CITY OF ALBUQUERQUE

December 19, 2017

RE: De Anza Grading Plan and Drainage Master Plan Stamp Date: 10/22/17 Hydrology File: K17D106

> SHEET TITLE SITE CONCEPTUAL DRAINAGE PLAN

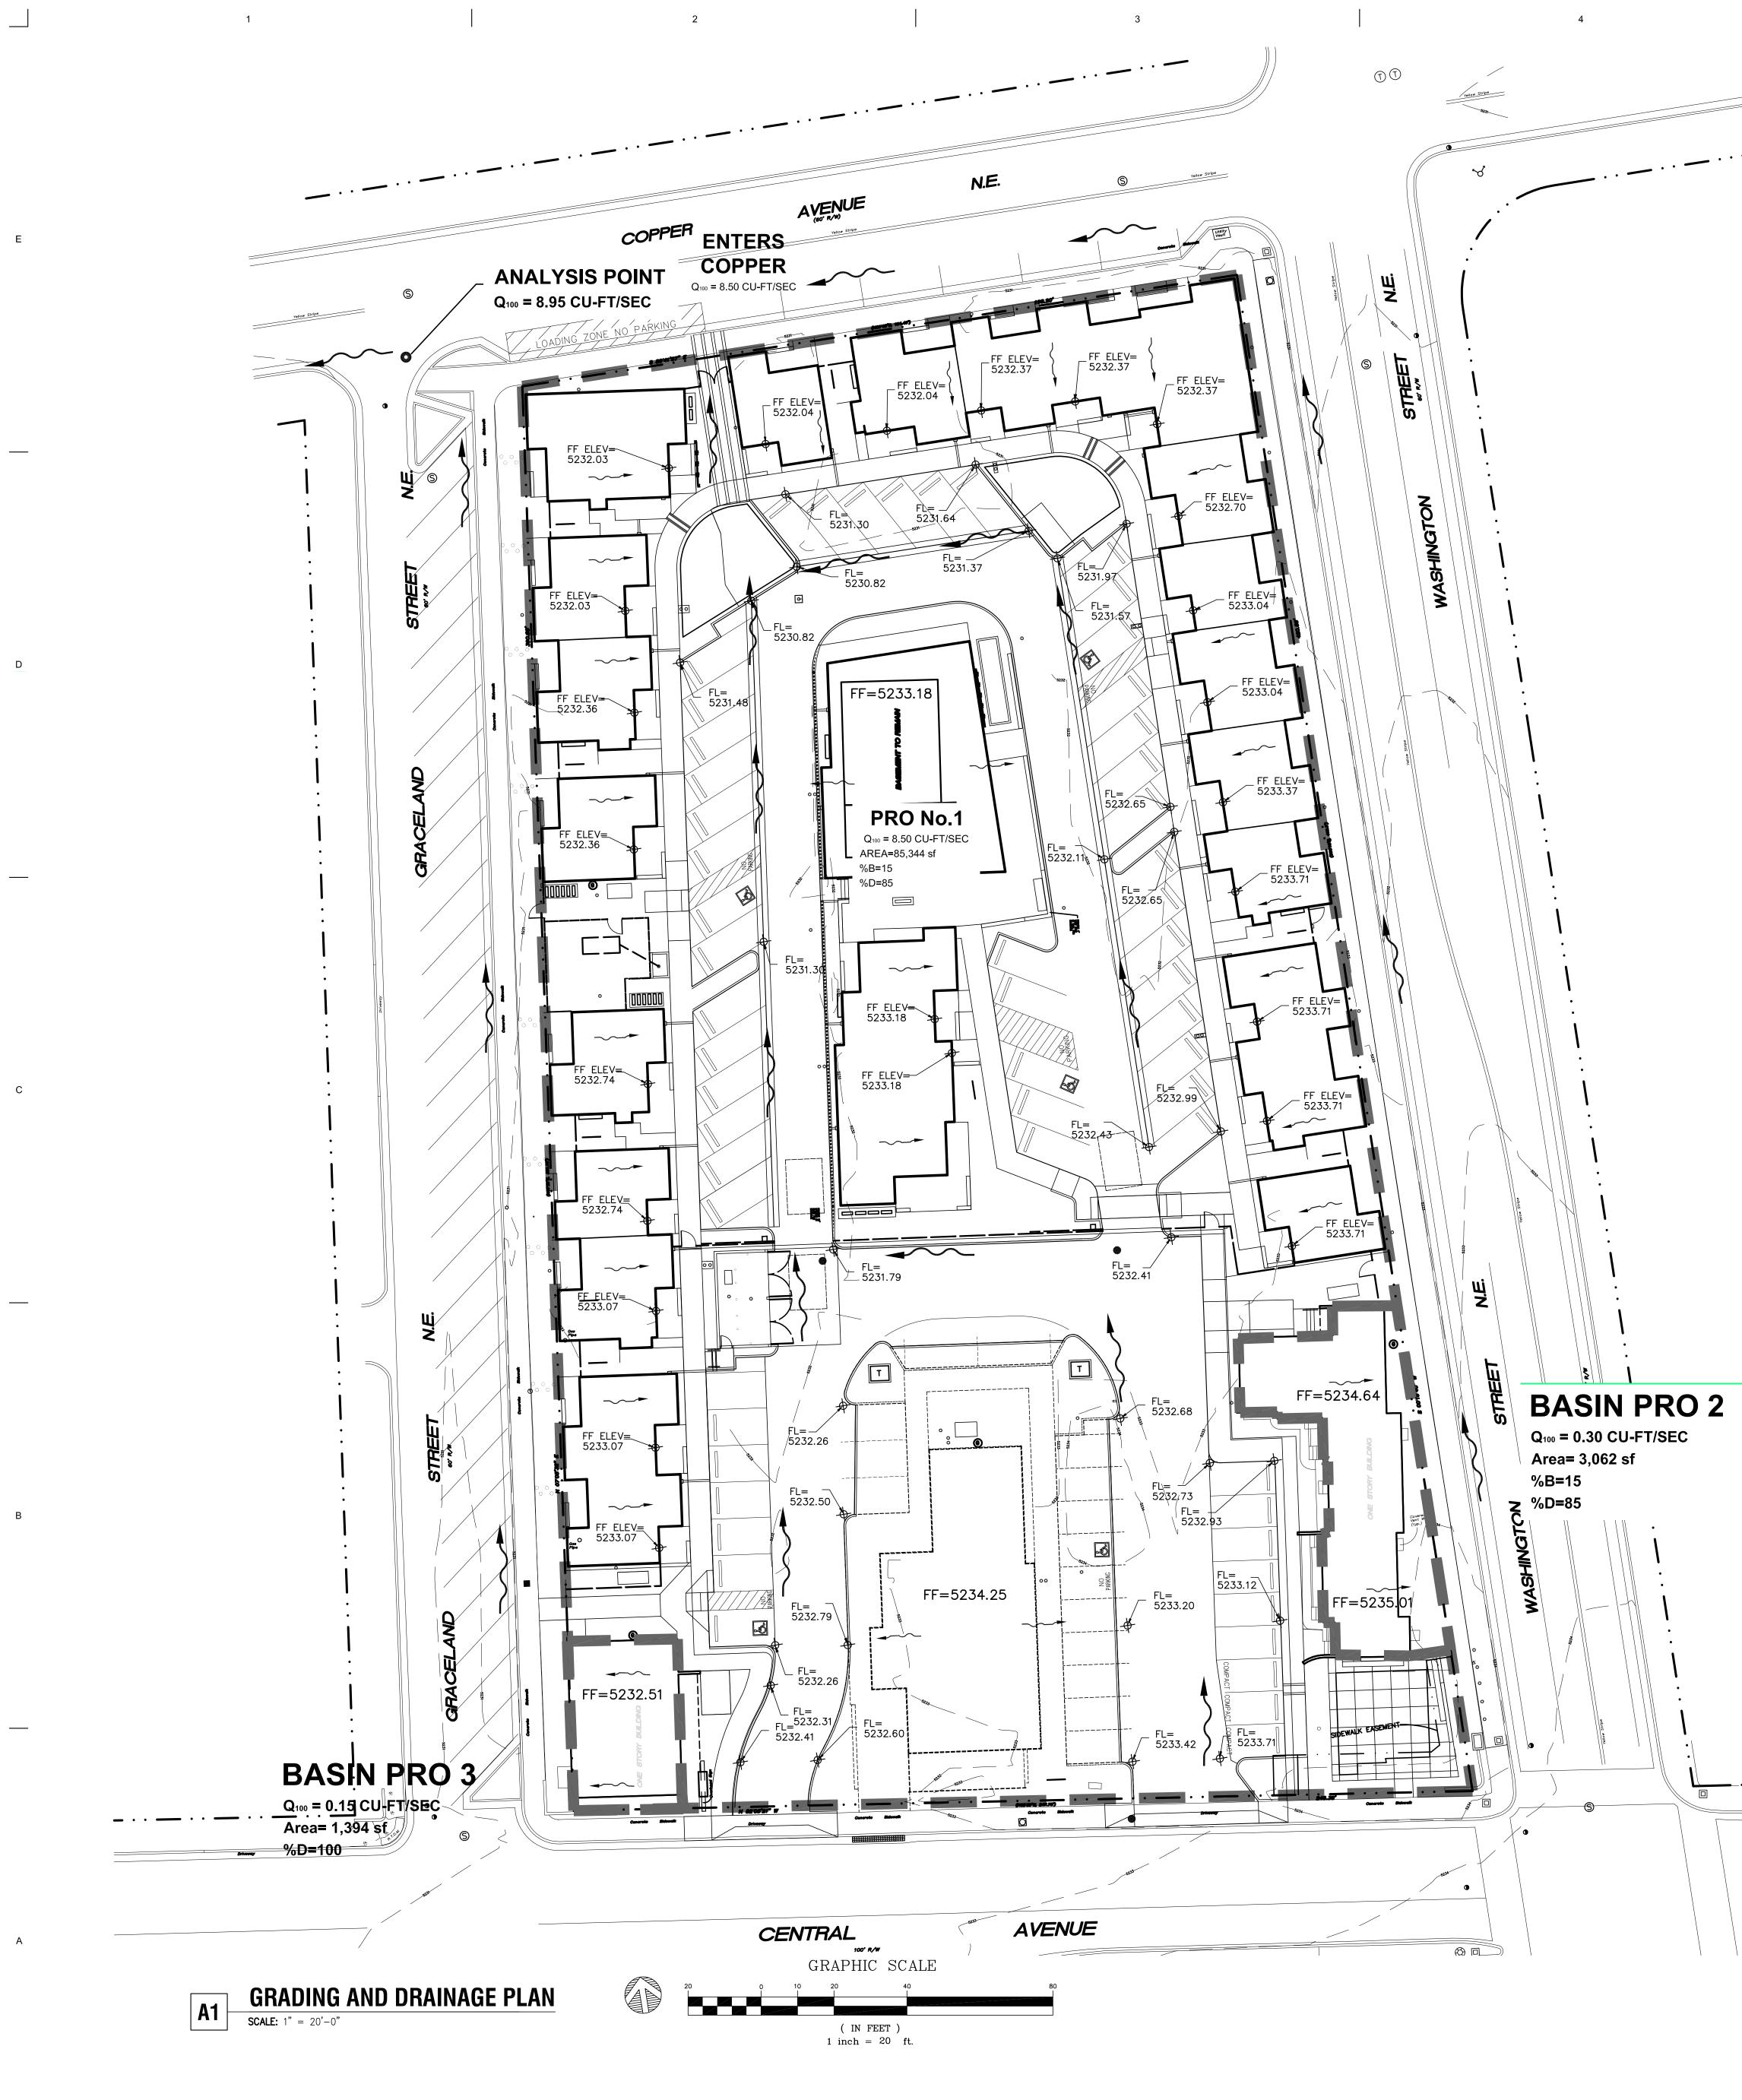
- Albuquerque 1. Please provide an engineer's stamp with a signature and date on all sheets.
 - 2. Please place engineering drawings on a maximum paper size of 24"x36".
- NM 87103 3. Sheet CD1. Please change the title to "Drainage Management Plan".
 - 4. Sheet CD2. Please label all the builds with the proposed building letters.
- www.cabq.gov
- 5. Sheet CD2. Please label the first flush ponds with the provided volume.
- 6. Sheets C-201, C-202, & C-203. These are duplicate sheets. There are no new information on these sheets. Please remove sheets.
- 7. Sheet C-204 thru C-212. The isometric drawings provided show no new information. Are these necessary? Also the proposed grades are very hard to read. If these are to stay, then make the proposed grades readable.
